**BROOKFIELD STREETScape PHASE II  
STATE PROJECT NO. 0018-0136  
FAP NO. 0202(015)  
TOWN OF BROOKFIELD**

**MAY 2, 2019**

**ADDENDUM NO. 2**

TITLE: TYPICAL SECTION  
 SHEET NUMBER: TYP-2.A2

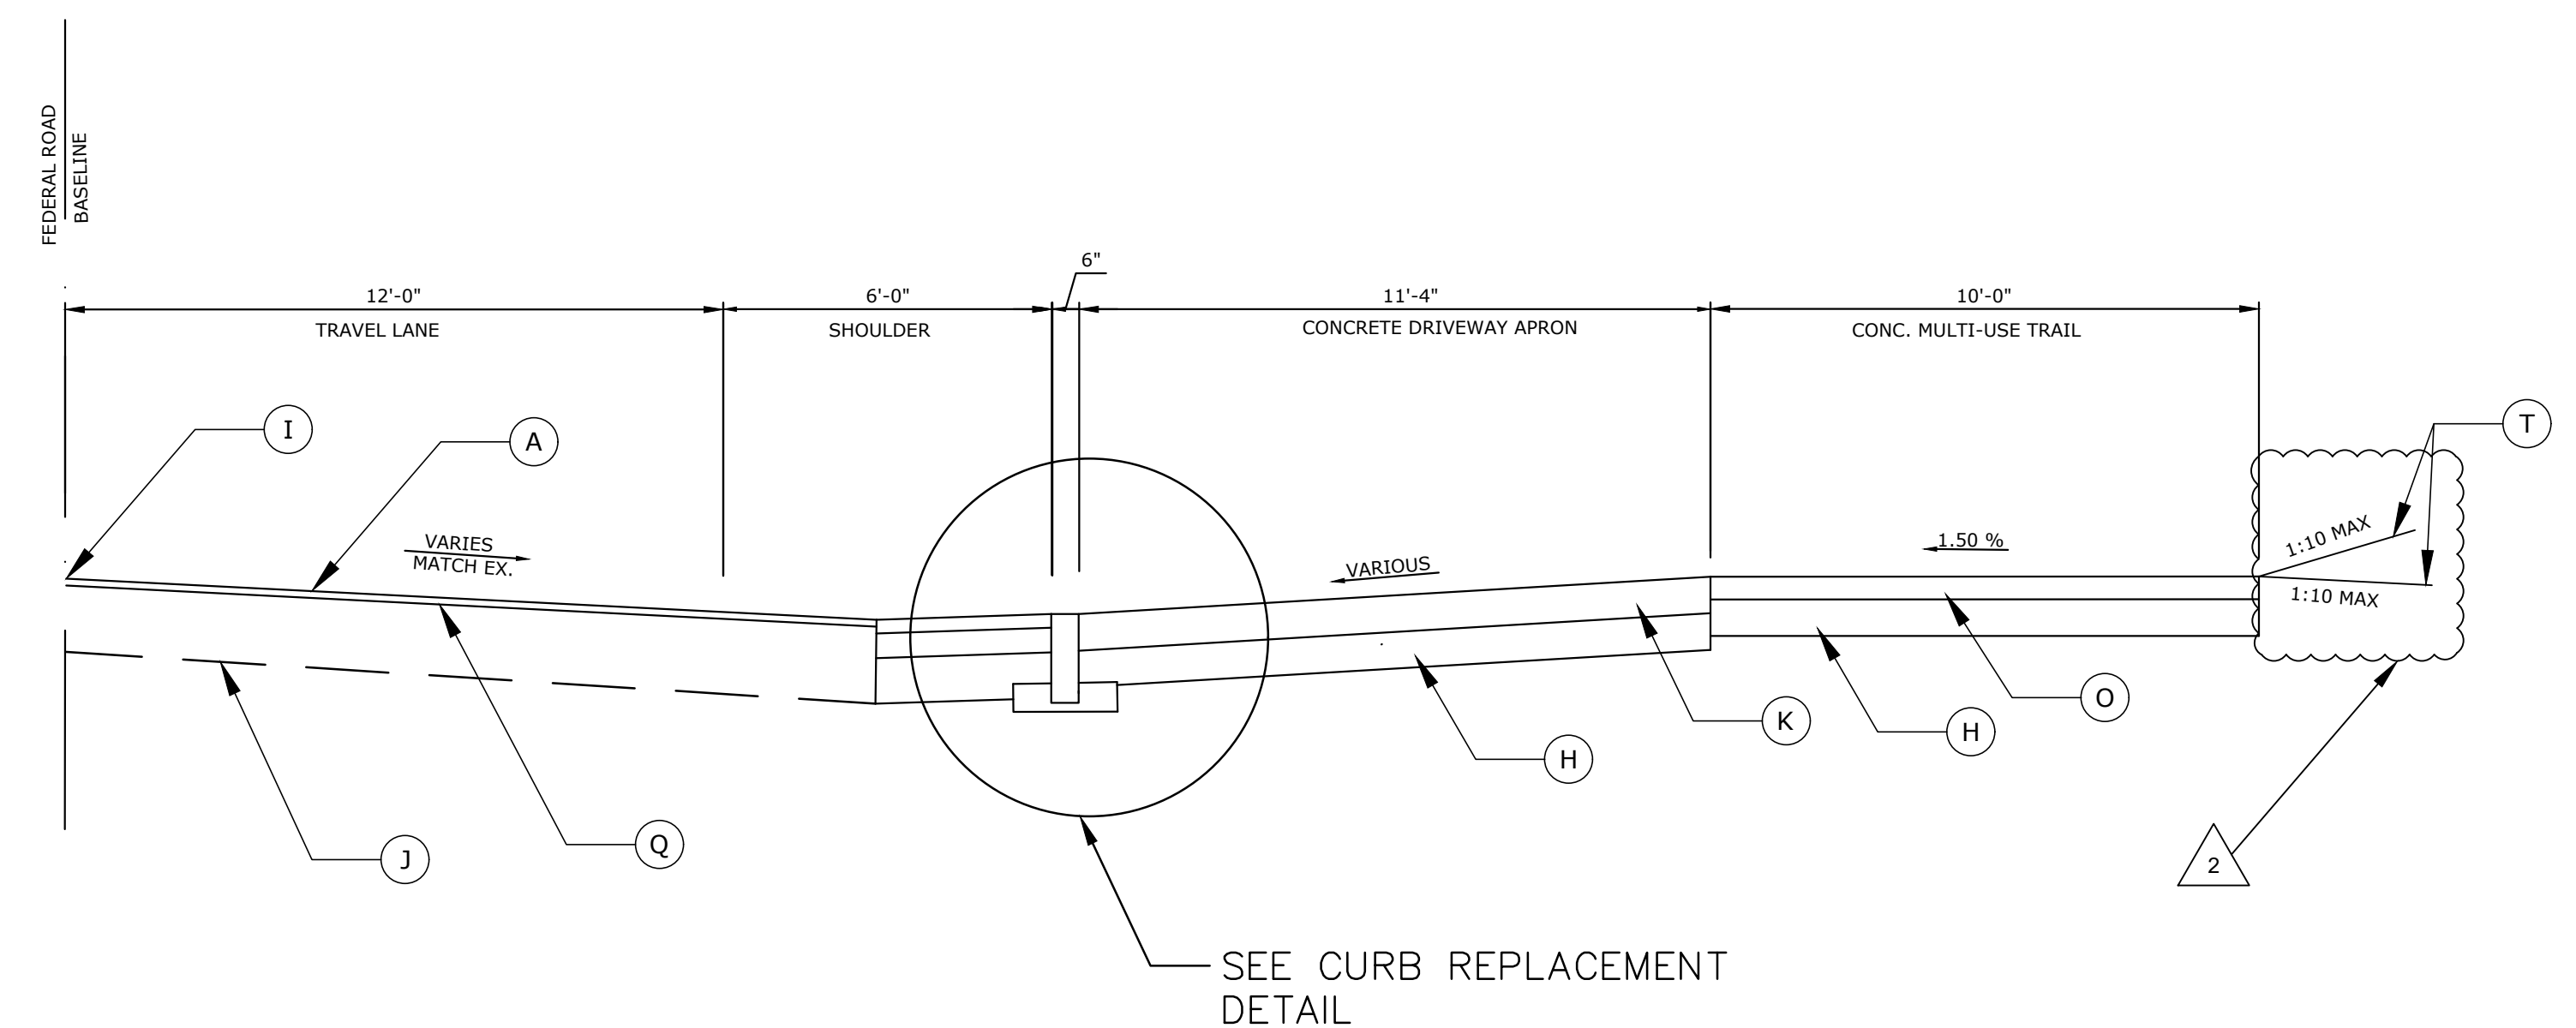
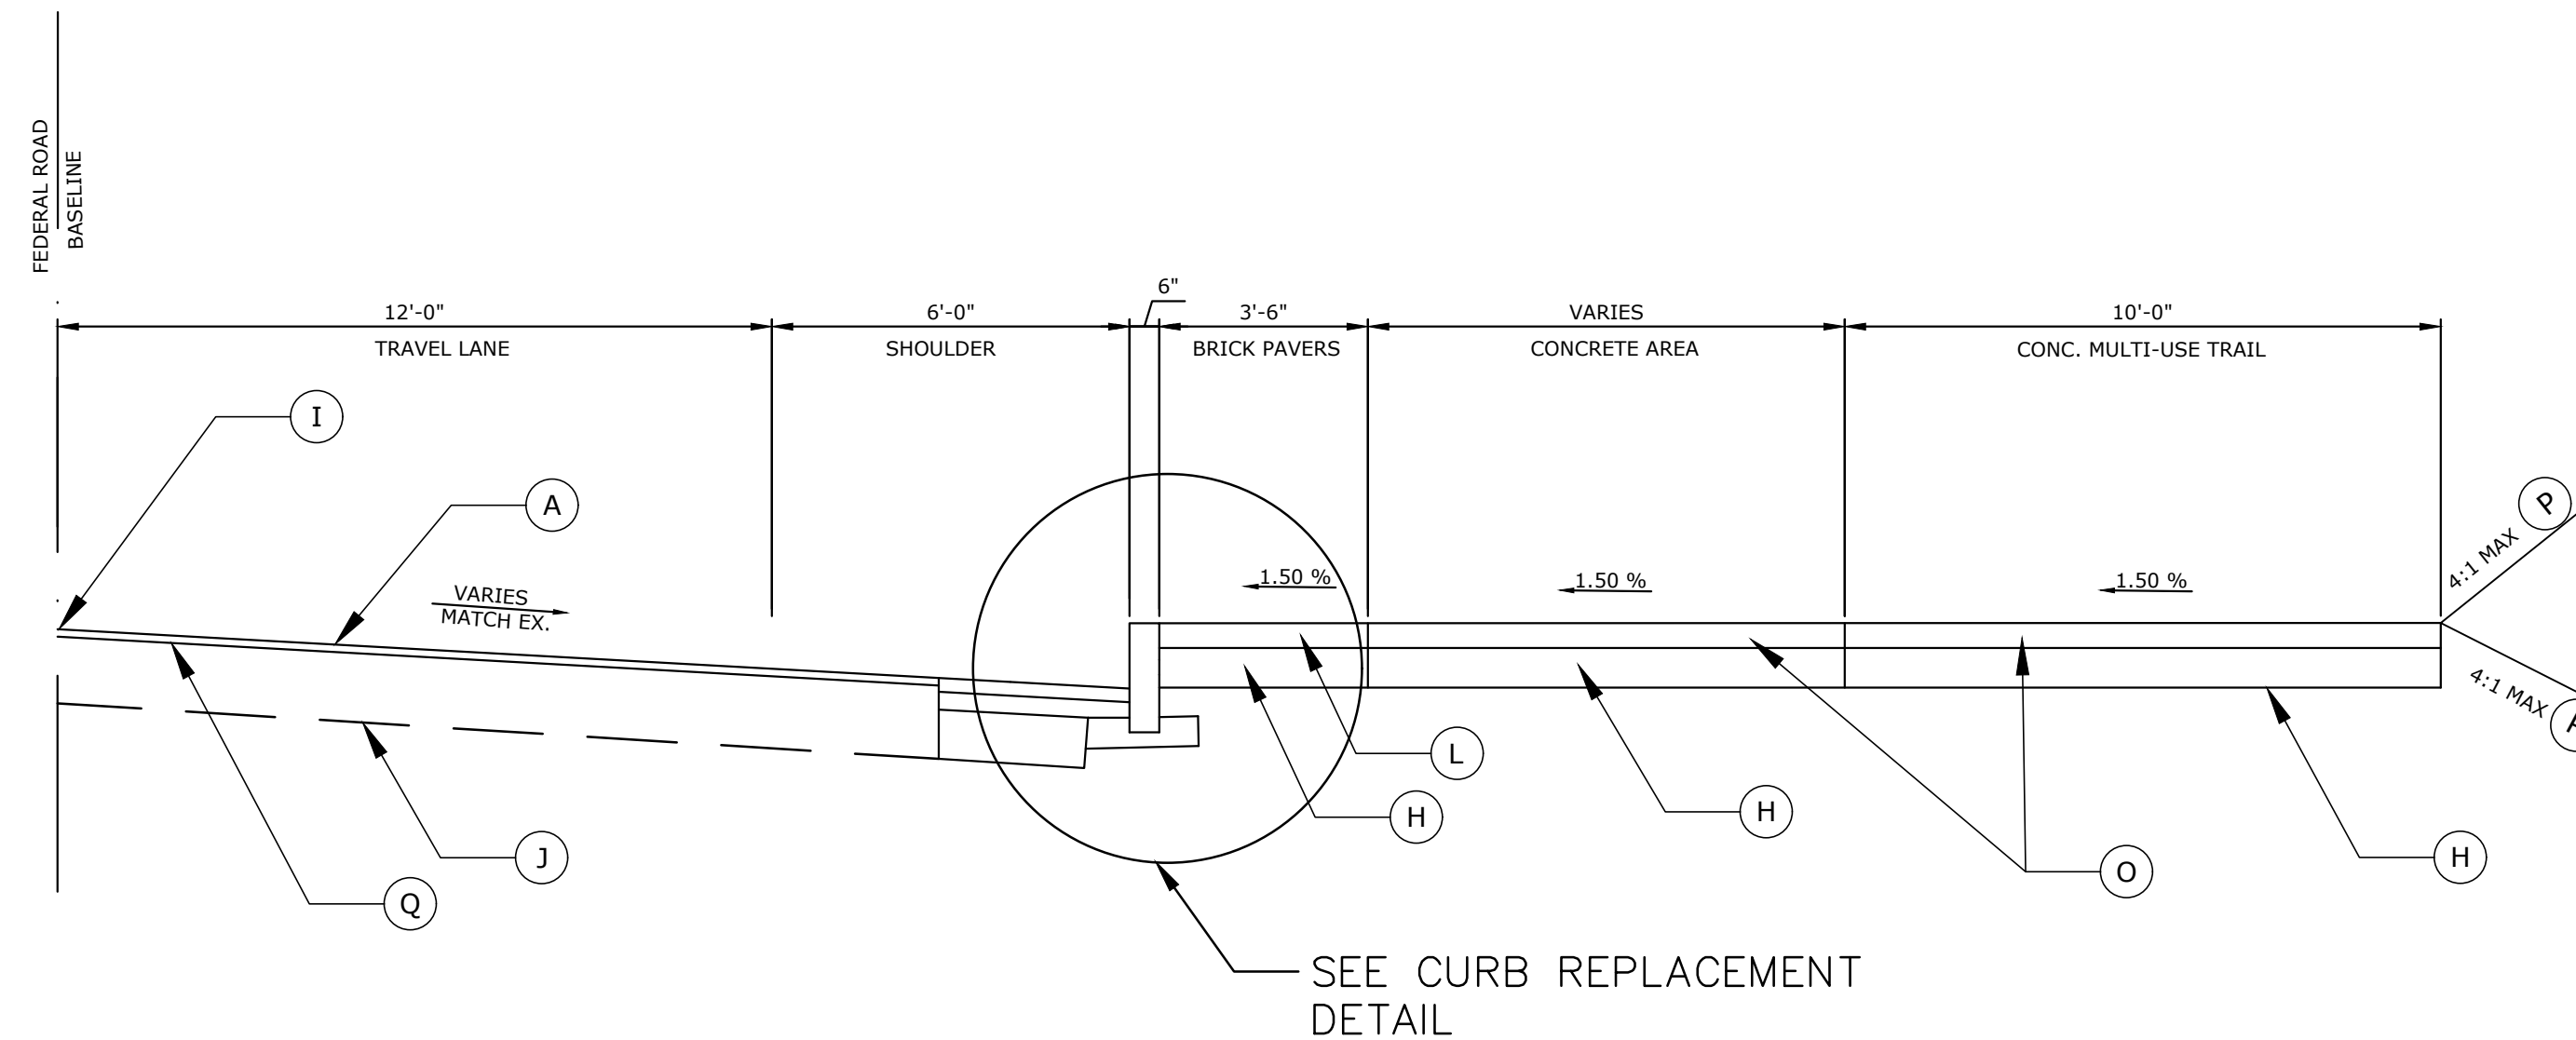
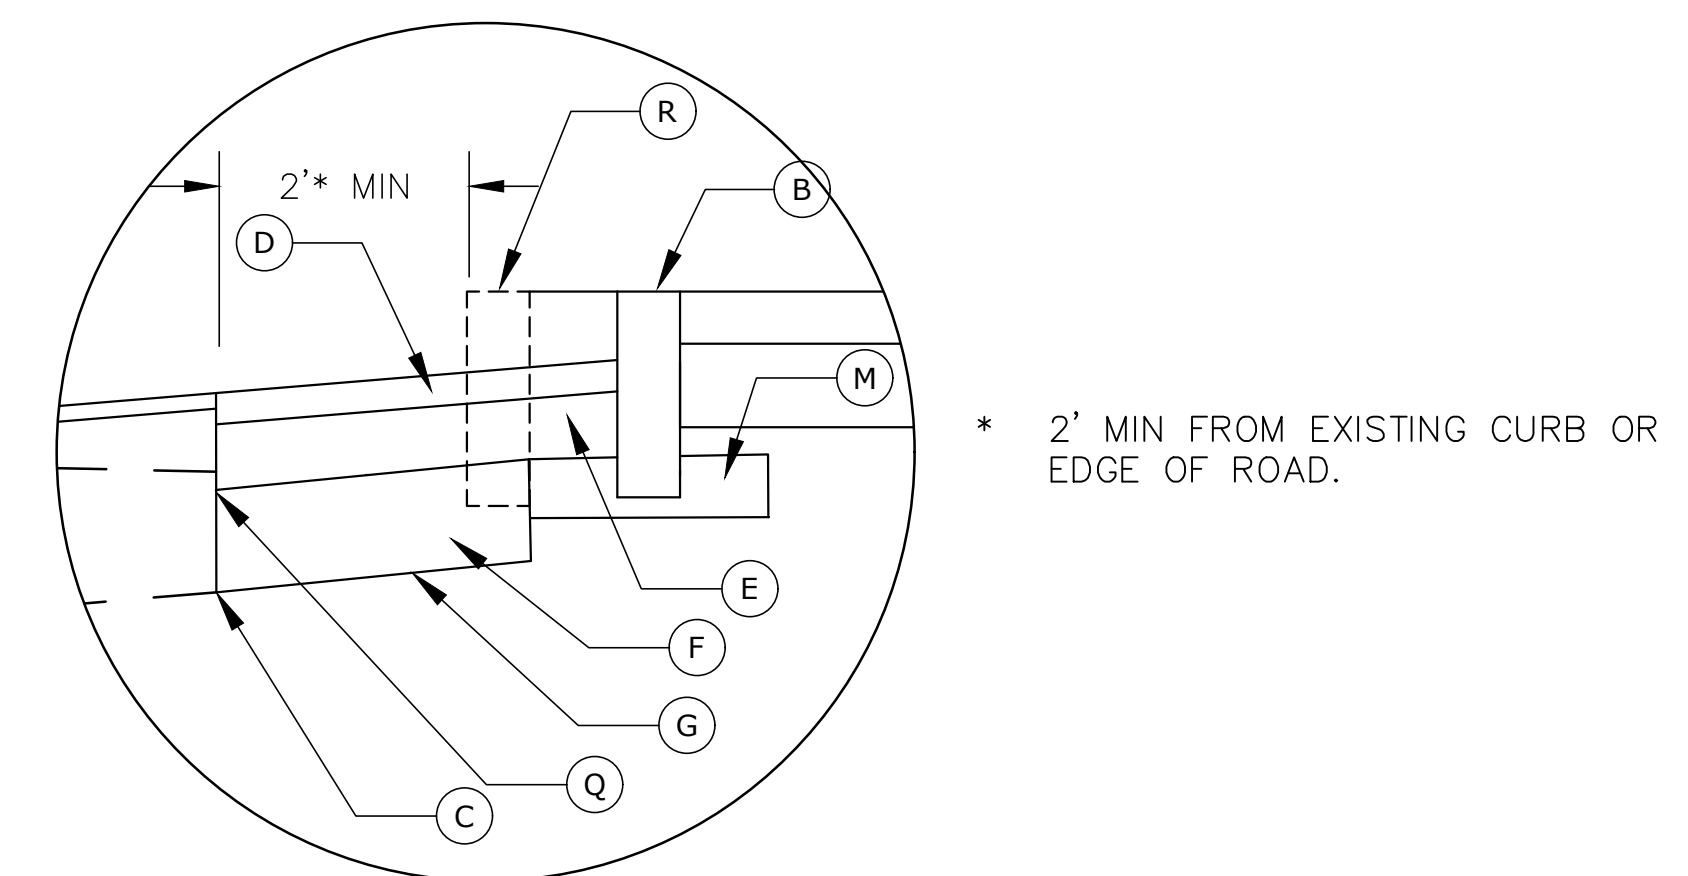
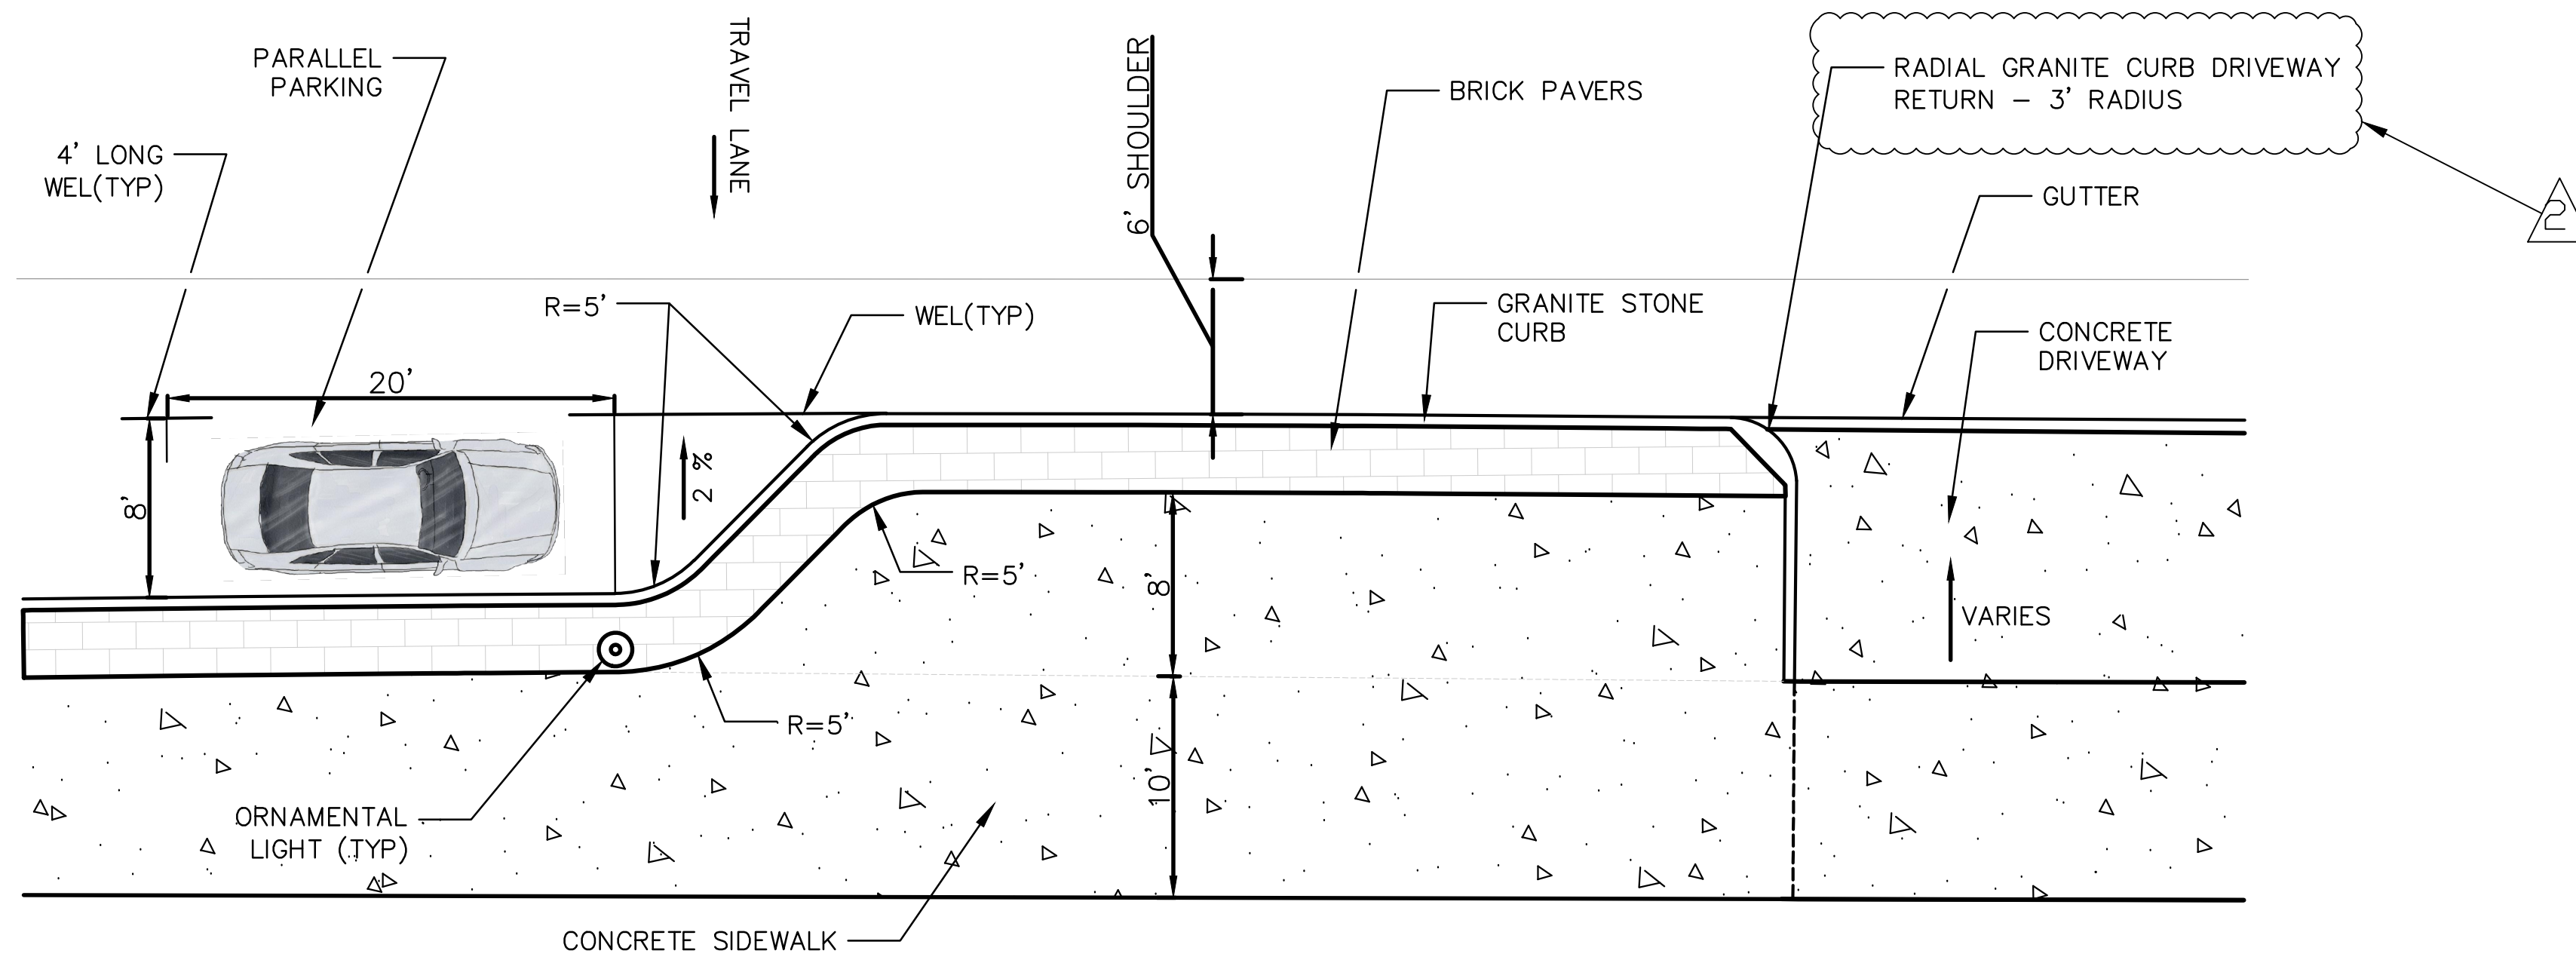
<b>SHEET NO.</b>	<b>SUMMARY OF REVISIONS</b>
<b>TITLE SHEET</b>	<b>General Note Revised</b>
<b>DE-1. A2</b>	<b>Item No. and Quantity Revised</b>
<b>TYP-1. A2</b>	<b>Driveway Slope Revised</b>
<b>TYP-2. A2</b>	<b>Driveway Slope and Legend Revised</b>
<b>MDS-1. A2</b>	<b>Miscellaneous Detail Callout Revised</b>
<b>MDS-2. A2</b>	<b>Miscellaneous Detail Revised</b>
<b>MDS-3. A2</b>	<b>Miscellaneous Detail Added and Revised</b>
<b>HWY-2. A2</b>	<b>Notes, Dimensions and Slope Limit Revised</b>
<b>PRO-2. A2</b>	<b>Catch Basin Type Revised</b>
<b>DRG-2. A2</b>	<b>Catch Basin Type Revised</b>
<b>XSC-1. A2</b>	<b>Brick Paver Width and slope limit Revised</b>
<b>XSC-2. A2</b>	<b>Brick Paver Width and slope limit Revised</b>
<b>XSC-3. A2</b>	<b>Brick Paver Width and slope limit Revised</b>
<b>XSC-4. A2</b>	<b>Brick Paver Width and slope limit Revised</b>
<b>XSC-5. A2</b>	<b>Brick Paver Width and slope limit Revised</b>

**MONOLITHIC CONCRETE CURB AND SIDEWALK**  
N.T.S. STA. 18+82± (L) TO STA. 19+82± (L)

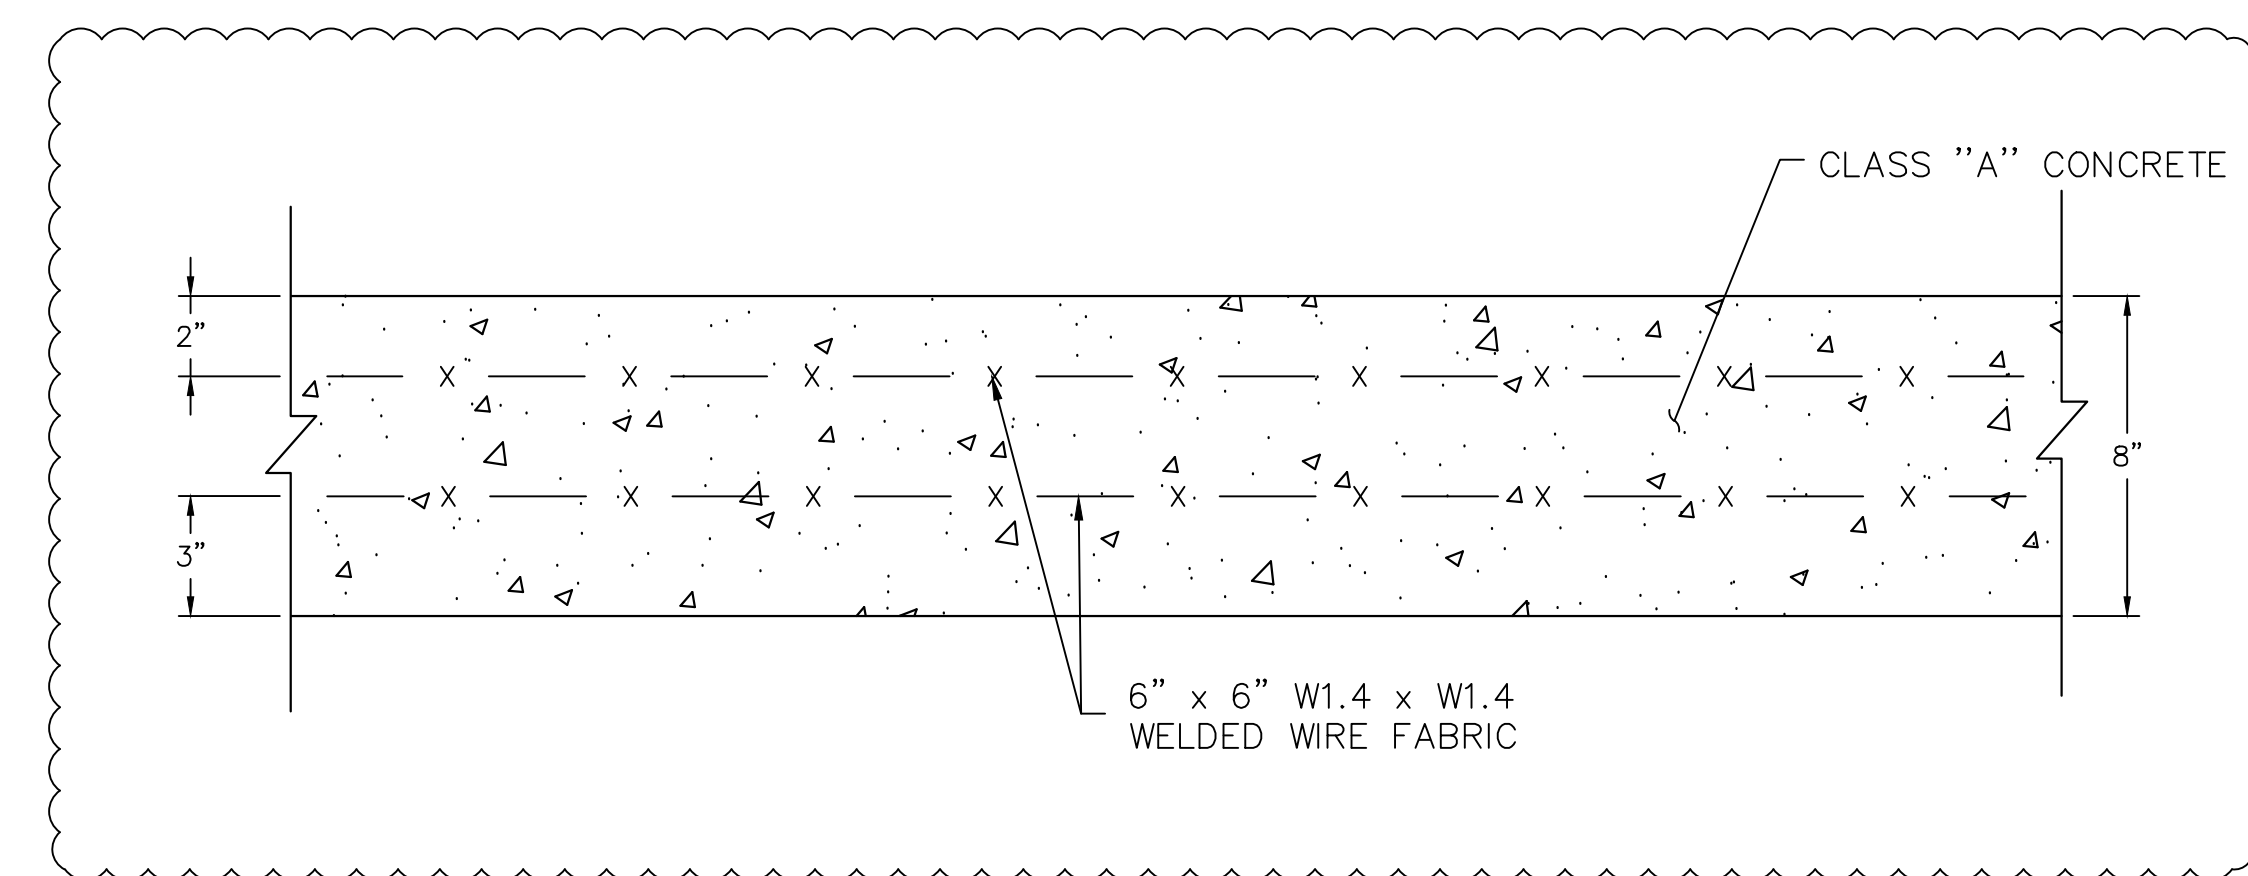
*Reason: Item numbers have been revised to reflect the use of all-inclusive drainage items. One Type "C" CB was changed to Type "C-L" CB to facilitate easier installation at a driveway. Monolithic Concrete Curb and Sidewalk was omitted and is hereby added to the contract.*

0202452A	Test Pit
0921010A	Monolithic Concrete Curb and Sidewalk
